R E M A R K S

THE DRAWINGS

Amendments to the Drawings:

Fig. 11(a)

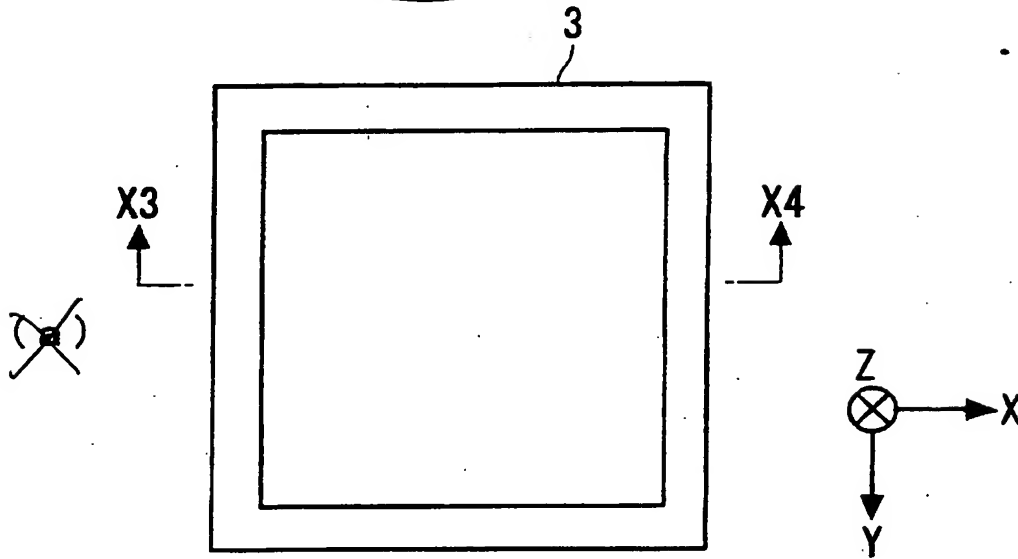
Figs. 11(a), 11(b), 12(a), 12(b), 12(c), 13(a), 13(b), 15(a), 15(b), 17(a) and 17(b) have been amended to be more clearly labeled. In addition, Figs. 17(a) and 17(b) have been amended to be labeled as Prior Art, as required by the Examiner.

~~Fig. 11~~

Fig. 12(a)

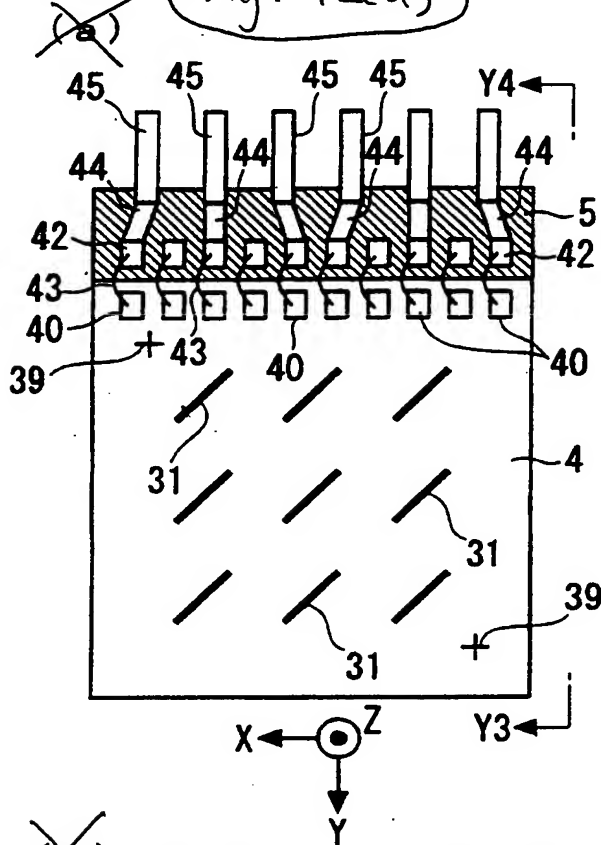
~~Fig. 12~~

Fig. 13(a)

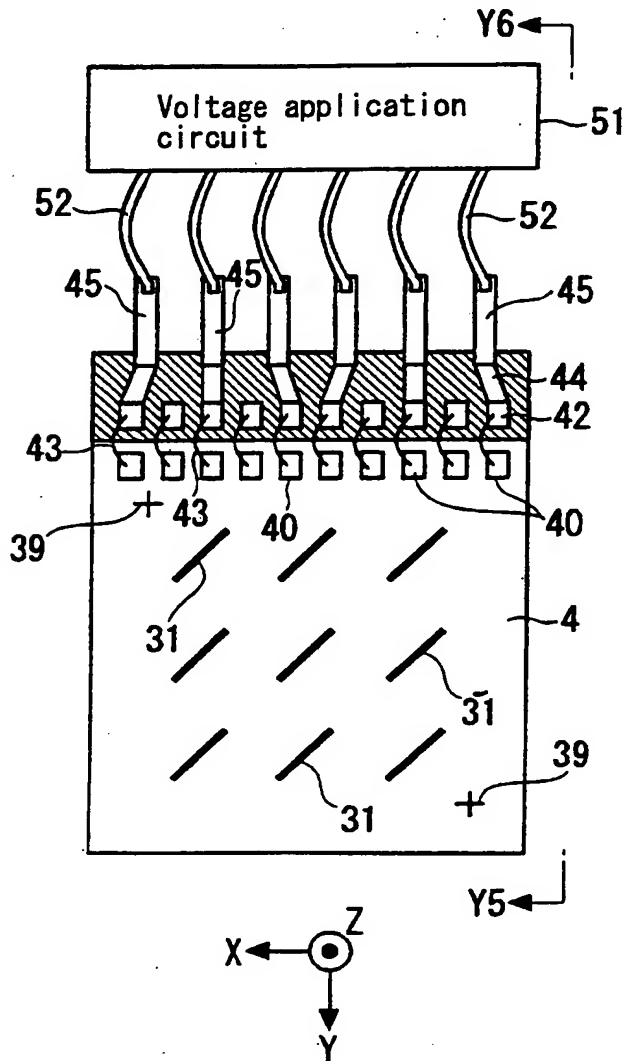
~~Fig. 13~~
